**MAJOR PROJECT ASSESSMENT:**

**Concept Plan for Settlers Ridge 140 Lot Residential  
Subdivision and BioBanking Proposal  
Steve Eagleton Drive, South West Rocks  
10\_0103**

Director-General's  
Environmental Assessment Report  
Section 75I of the  
*Environmental Planning and Assessment Act 1979*

June 2013

Figure 4: Proposed Concept Design – Settlers Ridge Residential Subdivision – Steve Eagleton Drive, South West Rocks (Preferred Project Report)

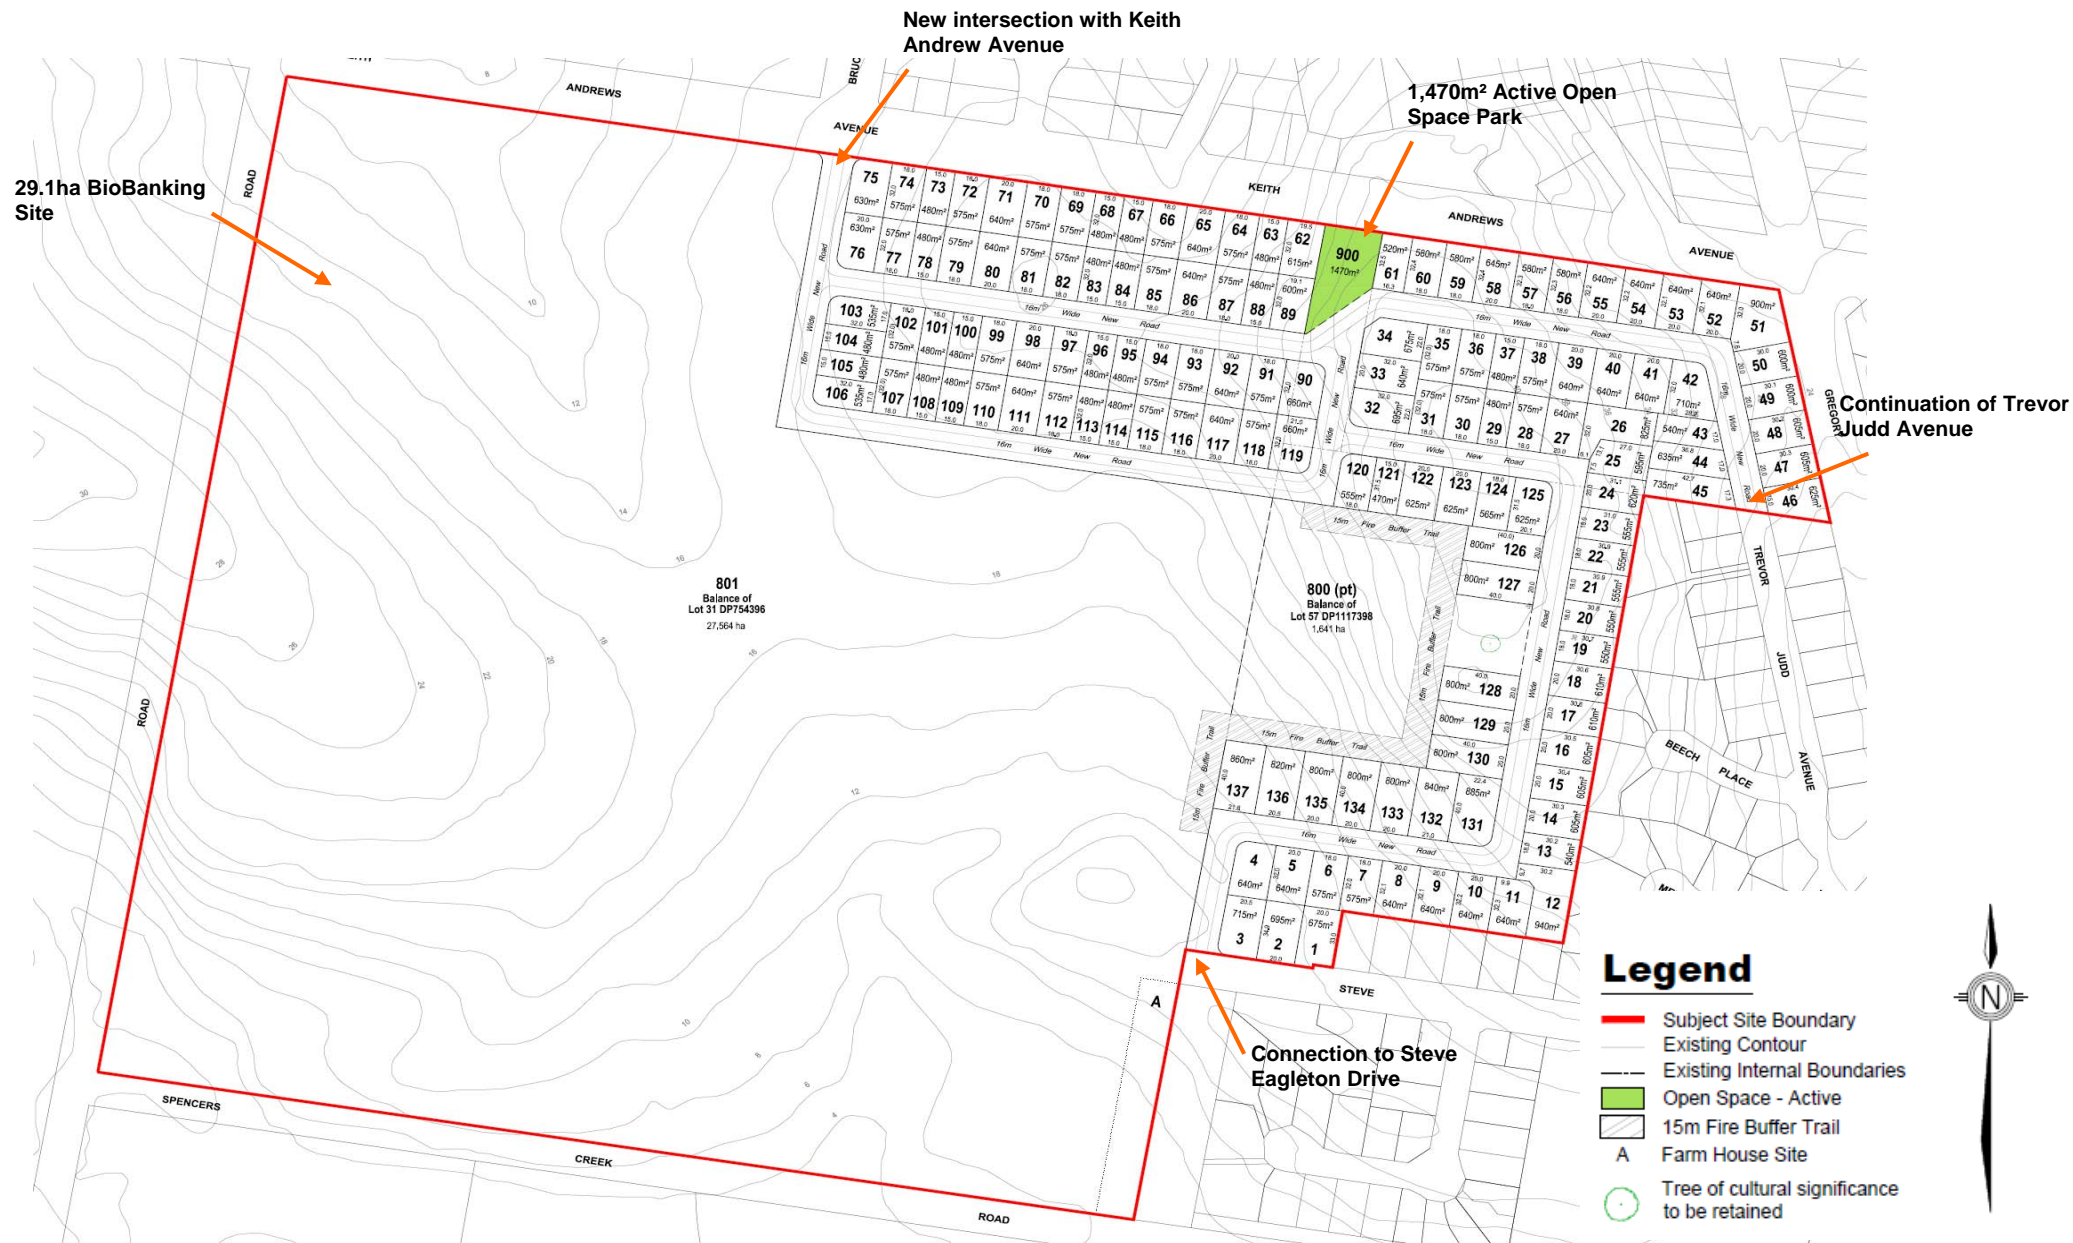
OEH's response to the revised design acknowledged the reduced development footprint compared to previous larger proposals. However, it was advised that there may be further opportunities to reduce the development footprint given the high conservation values of the site. Further reduction of the western extent of the development was therefore recommended.

The department considers the revised concept design has addressed the primary concerns raised during exhibition in response to the proposed site layout. The amendments made to the subdivision design ensure that the area proposed for biodiversity offsetting is contained within a single contiguous lot, consequently avoiding the fragmentation and isolation of existing habitat. The western extent of the development footprint has been reduced (including a reduced lot yield) in order to minimise the loss of native vegetation and

Whilst the department acknowledges OEH's recommendation to further reduce the development footprint, it is considered that the revised concept design achieves a satisfactory balance between sustainable urban development and the protection of existing native vegetation. It is noted that the site has been primarily zoned for residential use and the proposed subdivision will be an extension to existing residential development. A large portion of the site currently zoned for potential future residential development is proposed to be utilised as biodiversity offsetting as part of the application, effectively ensuring the ongoing protection of this land in perpetuity.

**Figure 8: Proposed Concept Design – Environmental Assessment**

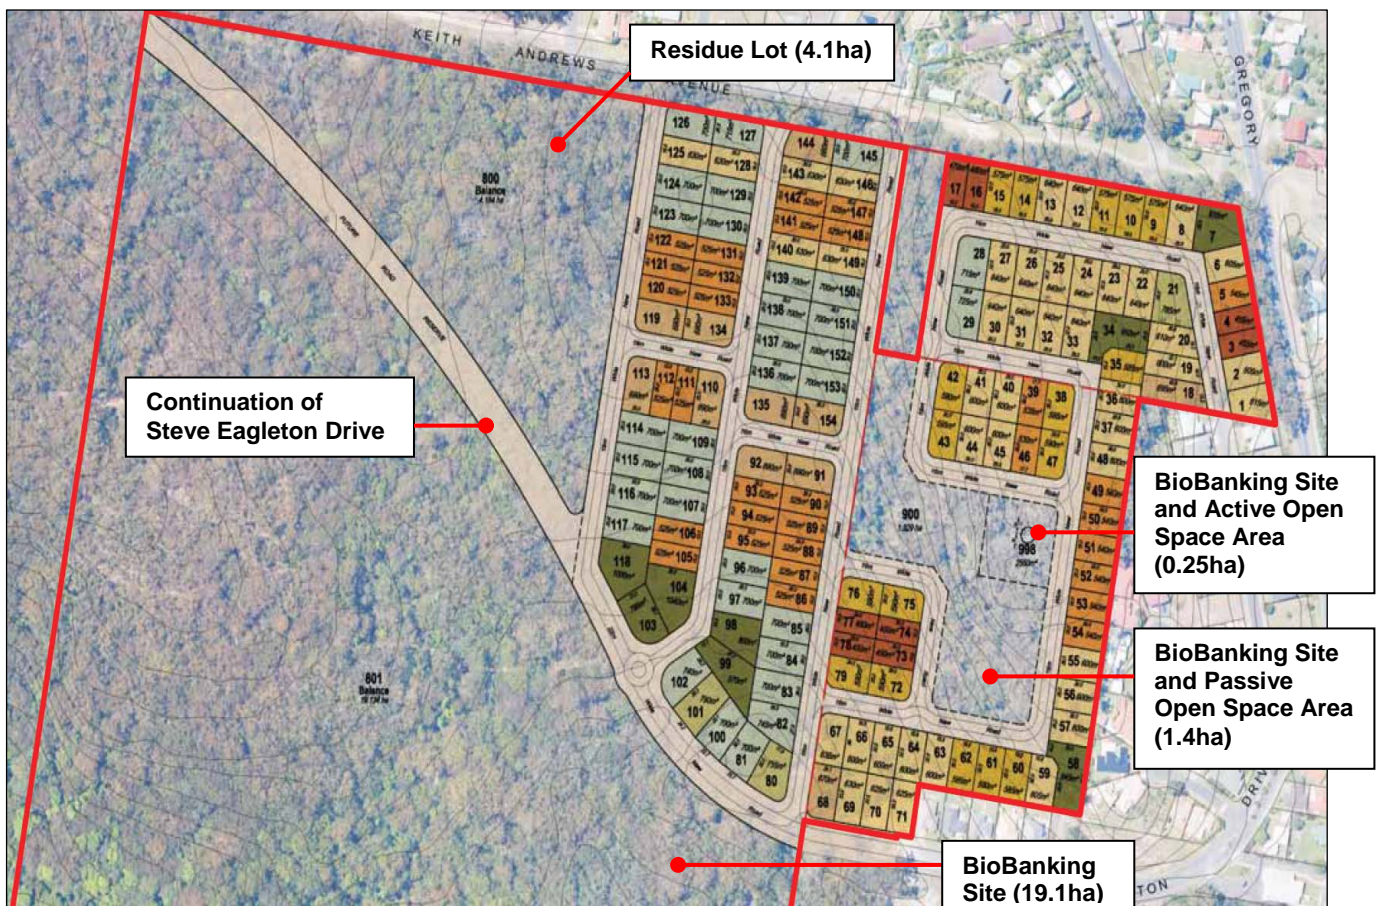
Concern was raised by the department, government authorities, and the general public in response to the subdivision design and layout presented as part of the EA. The concerns raised were primarily in regards to the removal, fragmentation, and isolation of existing native vegetation and threatened species habitat; and associated cumulative impacts on threatened species known to inhabit the site and surrounding locality. The ecological impacts of the proposal are assessed under **Section 5.2** below.

The department requested the proponent consider a revised concept design which better responds to the existing threatened species habitat and provides improved vegetation connectivity throughout the site. The department advised that a revised concept design should aim to achieve the following outcomes:

In response to the issues raised during the public exhibition period, the proponent submitted a revised concept design for the site as part of the PPR. Amendments made to the original proposal include:

**Figure 10: On-Site Biodiversity Offsetting Area (source: Preferred Project Report)**

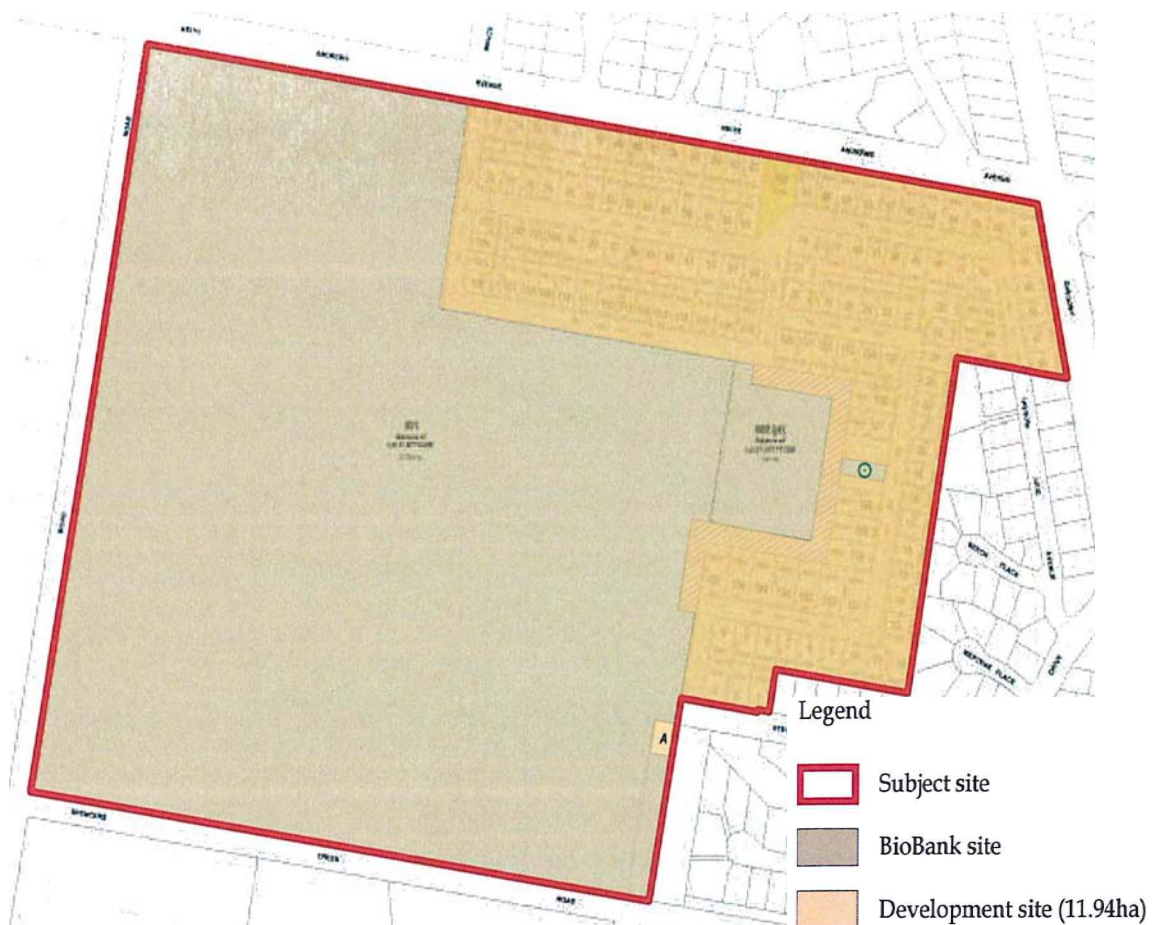
The department's submission on the EA raised concern with the 2.8ha biobanking lot within the eastern portion of the site given it was proposed to be surrounded by perimeter roads and residential lots on all sides, and was also to be utilised as active and passive open space. As discussed under **Sections 5.1** and **5.2.1** above, the department requested the proponent submit a revised concept design with the aim of avoiding the fragmentation and isolation of vegetated land, and to provide a contiguous vegetated lot for on-site biodiversity offsetting. In addition, the department requested the proponent consider incorporating the 4.1ha residue lot as part of the on-site biodiversity offsetting area.

OEH advised in its submission that the proponent had pursued the least preferred option of compensating for impacts through the use of biobanking, and that further avoid options should be explored. OEH also sought further clarification in regards to the biobanking calculations.

OEH advised in its submission on the PPR that a number of variations to the biobanking calculations were required. Variations related to the data entered into the biobanking credit calculator to obtain an accurate number of credits the site is capable of generating. In order to address this issue, the department recommends a modification to the concept plan requiring the re-calculation of biodiversity credits, to be carried out in consultation with OEH. It is recommended that OEH review, and indicate support in writing, of the re-calculated biodiversity credits prior to final concept approval being provided.

The revised concept design submitted as part of the PPR incorporates adjoining Lots 800 and 801 to form a single contiguous area of 29.1ha for biodiversity offsetting. **Figure 10** below shows the proposed on-site biodiversity offsetting area.

The revised proposal submitted as part of the PPR also includes an overall increase of 6ha for on-site biodiversity offsetting. The 6ha increase subsequently required a re-calculation of the number of biodiversity credits the site could provide. A revised biobanking statement was submitted as part of the PPR which included a total of 665 ecosystem credits and 238 species credits required to be sourced in order to offset the impact of the revised proposal.

**Figure 11: Recommended Asset Protection Zones (source: RPS)**

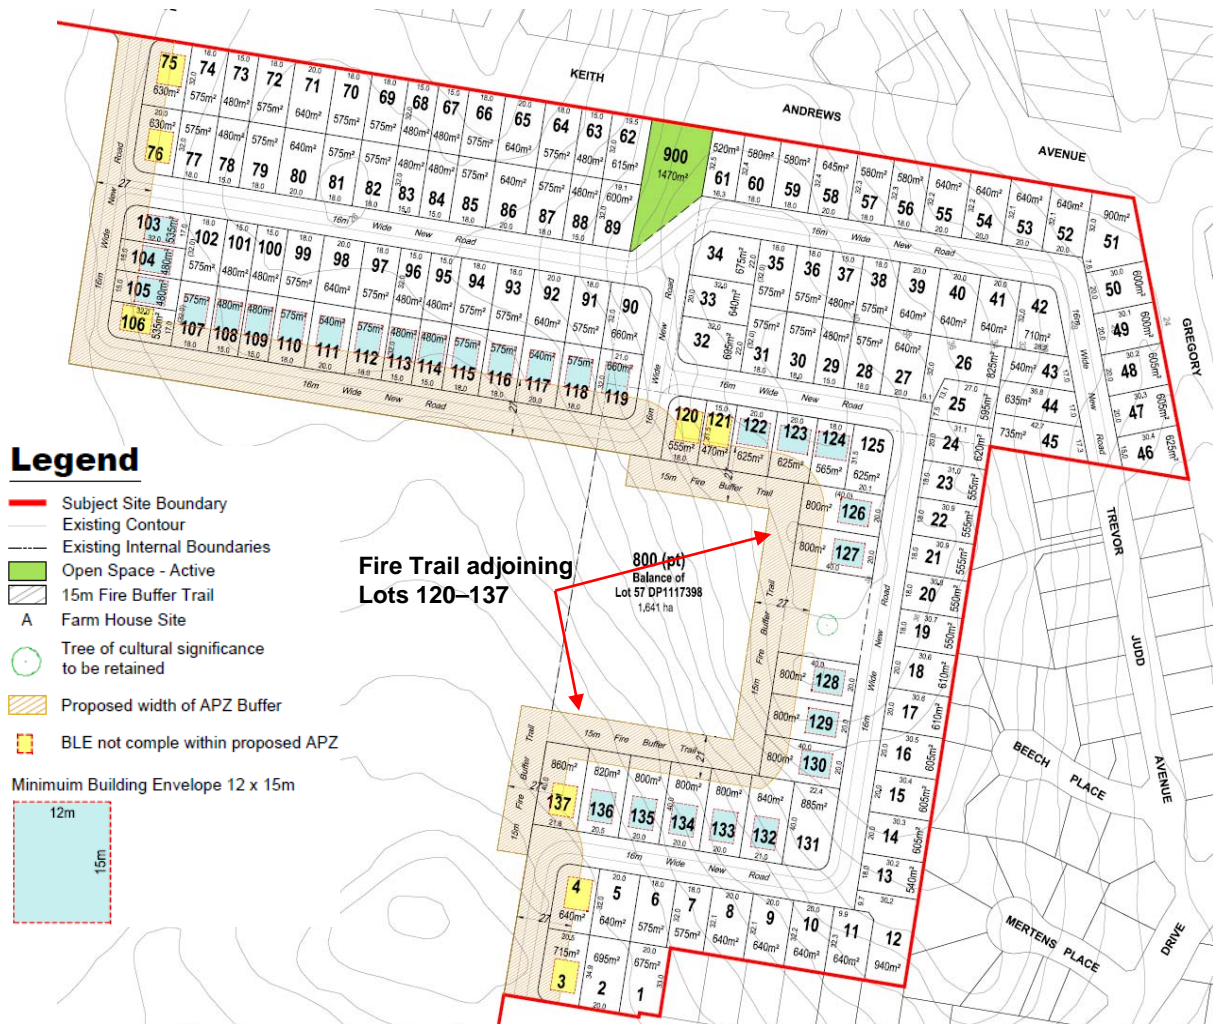
The department requested the proponent provide a plan of subdivision illustrating the recommended APZs and potential for a future building envelope on each lot – refer **Figure 11** below. It is noted that eight proposed lots are unable to contain a dwelling without encroachment within the APZ.

In response to the revised concept design, the RFS advised that further information would be required upon assessment for any future residential development on the site. The RFS specifically requested a land survey report be prepared that identifies the effective slope under the bushfire hazard for a distance of 100m from proposed residential lots, as well as

subdivision plans that identify the required APZs to achieve a bushfire attack level (BAL) 29 in accordance with AS3959–2009: Construction of buildings in bushfire-prone areas.

In addition, the department recommends a modification to the concept plan requiring the proposed subdivision layout to be reconfigured to ensure all lots are capable of containing a dwelling outside of the identified APZ. Lots 3, 4, 75, 76, 106, 120, 121, and 137 are therefore not approved as part of the application.

**Figure 13: Proposed Pedestrian Pathway Network (Source: Preferred Project Report)**

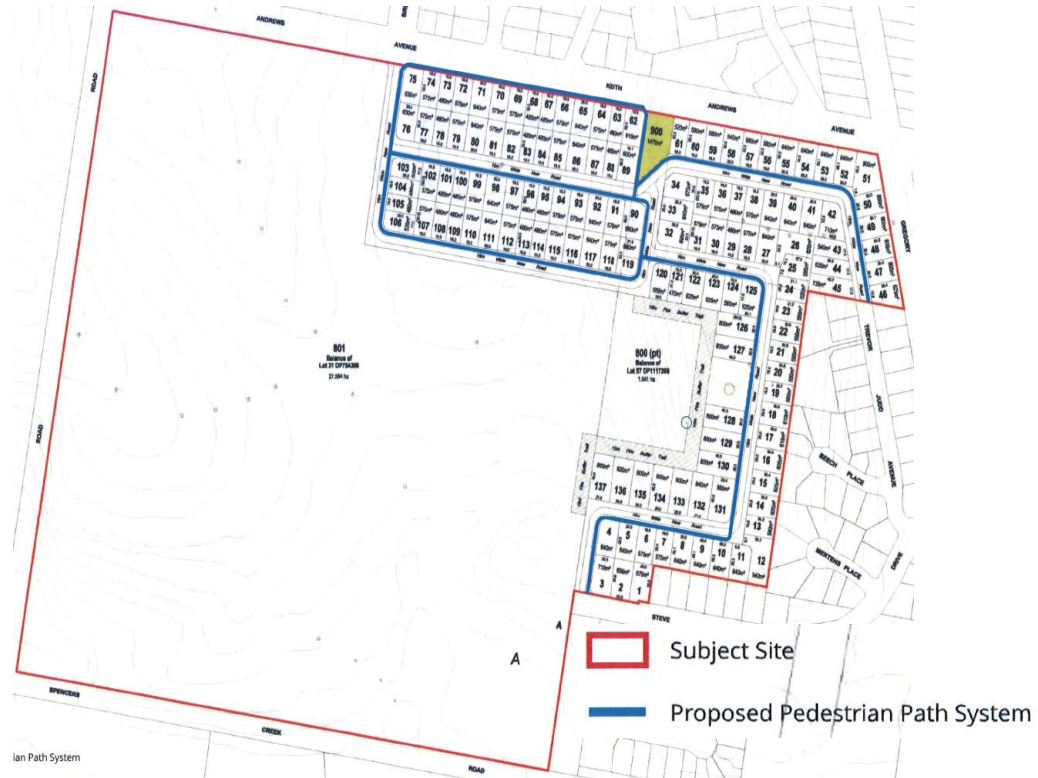
In response to pedestrian and cyclist connections, **Figure 13** below illustrates the proposed pedestrian pathway network throughout the site. A recommended term of approval requires any future development applications to make provisions for pedestrian pathways, in accordance with the plan shown at **Figure 13**.

**Figure 14** below shows the approximate location of the acoustic barrier (in green) as recommended in the Acoustic Assessment, and those lots which are recommended for single-storey construction only.

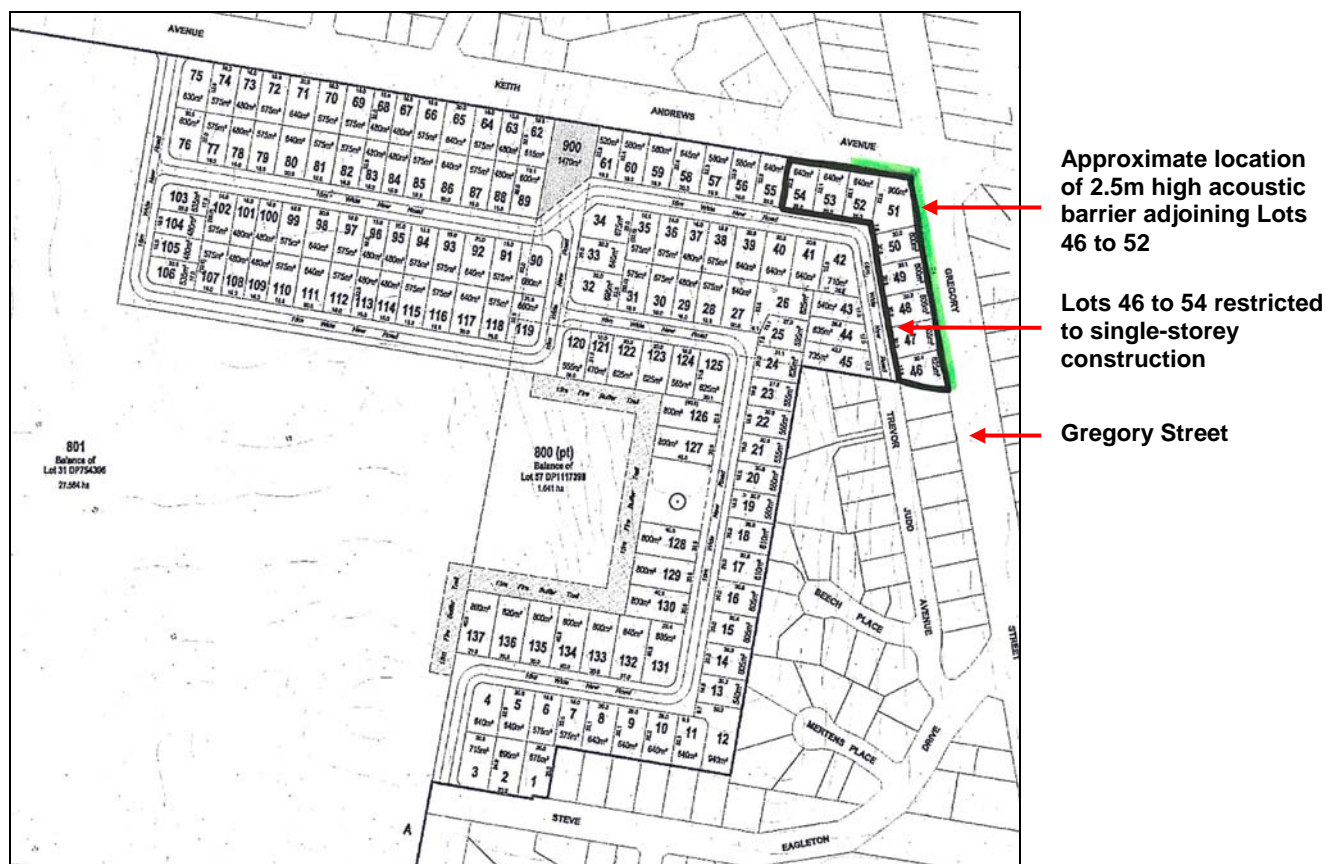
The Acoustic Assessment identified road traffic noise emanating from Gregory Street (a sub-arterial road) as the primary noise impact upon future residents within the subdivision. In order to address this concern, it was recommended that:

- a 2.5m high acoustic barrier be provided along the rear boundaries of proposed lots adjoining Gregory Street; and
- a single-storey construction limit be applied to proposed Lots 1 to 10 (the equivalent of Lots 46 to 54 on plans submitted as part of the PPR).
